Site Name: EAST PECOS FEDERAL 22 #009H	Site Type: Oil Production Site
Date Release Discovered: January 4 th , 2022	API# (if applicable) 30-015-43349

**Re: Remediation Work Plan Addendum
East Pecos Federal 22 #009H
Incident Numbers NVV2003433576, NRM1935238930, NRM2001038937 and
nAPP2200730406
Eddy County, New Mexico**

WPX ENERGY PERMIAN, LLC.
EAST PECOS FEDERAL 22 #009H
Unit M, Sec 22, T26S, R29E, Eddy County, New Mexico
32.020824° N, 103.975286° W

SOIL SAMPLE LOCATIONS

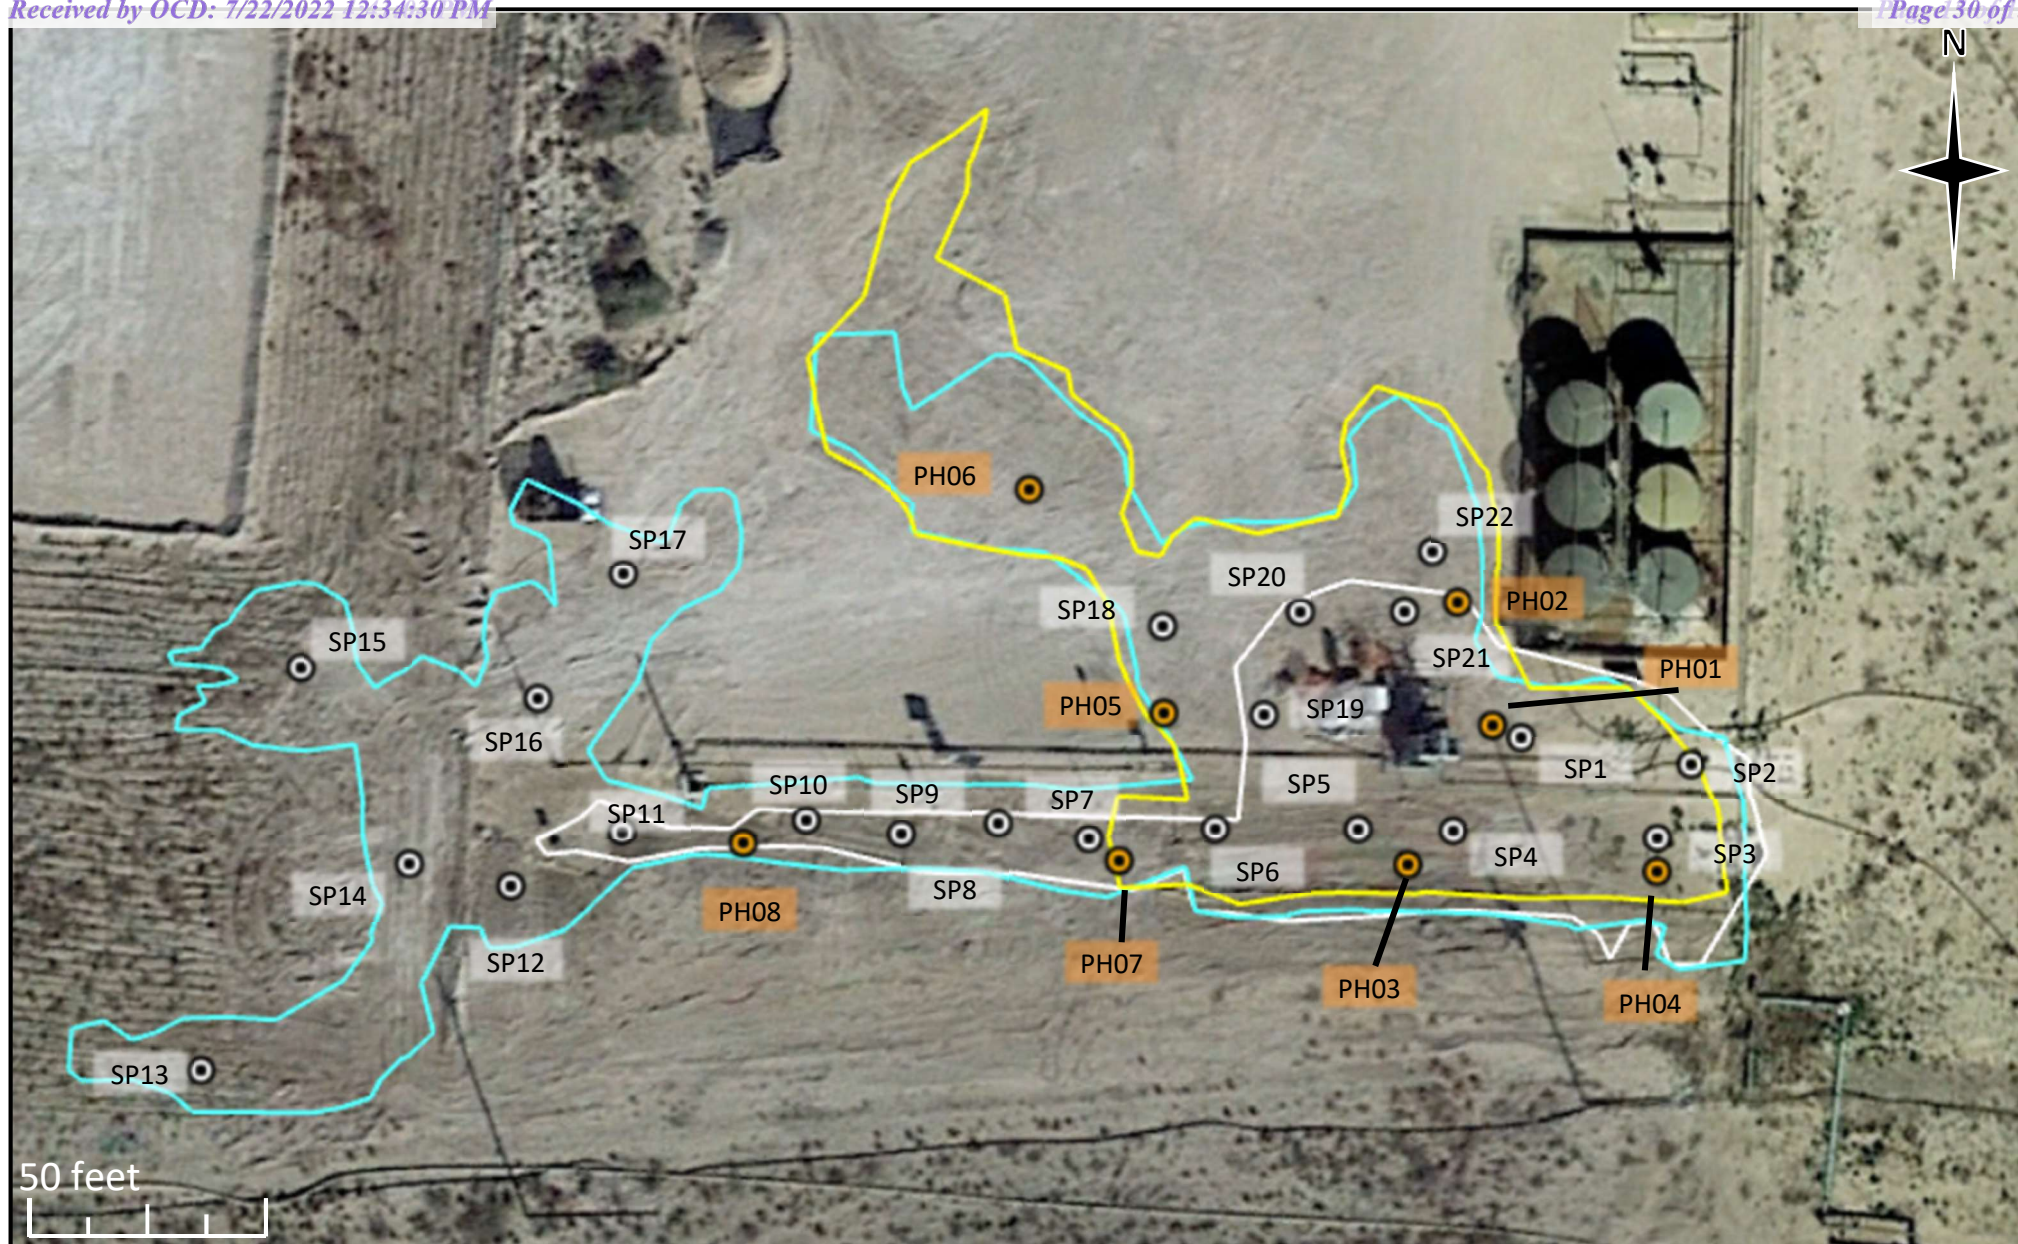
- Based on laboratory analytical results associated with delineation soil samples PH03 and PH04 and surface soil samples SS02 and SS04, concentrations of contaminants of concern (COCs) greater than the NMOCD Closure Criteria will be excavated and sampled in accordance with the Closure Criteria and/or Reclamation Standard (**See Figure 2 in Appendix A**);
